### **ROYSE CITY GENERAL CONSTRUCTION NOTES & DETAILS**

**City of Royse City Special Provisions to Section II**  
**Standard Drawings of the Standard Specifications for Public Works Constructing**  
**North Central Texas, 4<sup>th</sup> Edition, dated October 2004**  
**(City's Revisions - March 2012)**

## WASTEWATER LATERAL CONNECTIONS

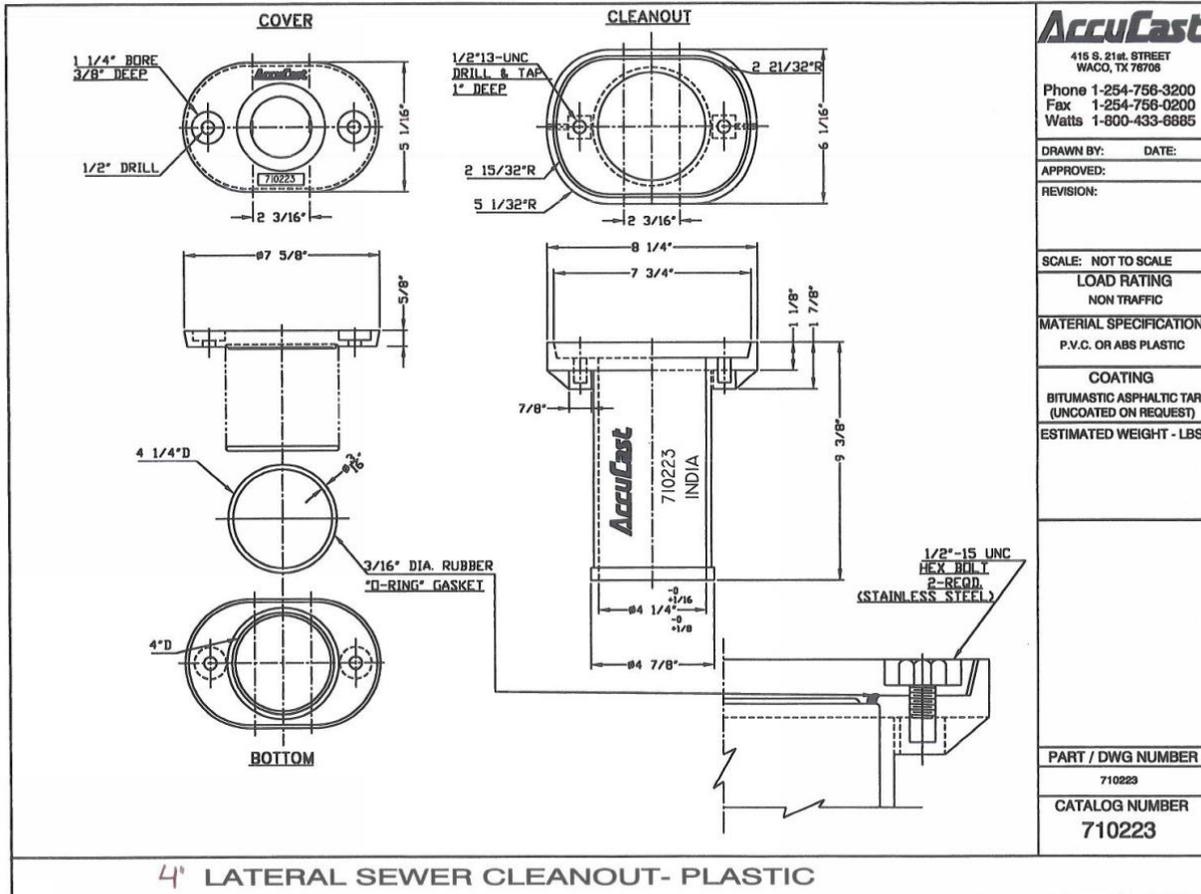
1. Replace with City Detail.
2. Green EMS disk shall be installed at cleanout or end of lateral.
3. Cleanout shall be cast iron sewer cleanout, Type Trinity Valley, Pattern 1684 or approved equal.
4. If cleanout is installed in roadway or parking area then traffic cleanout shall be designed to handle traffic loads.
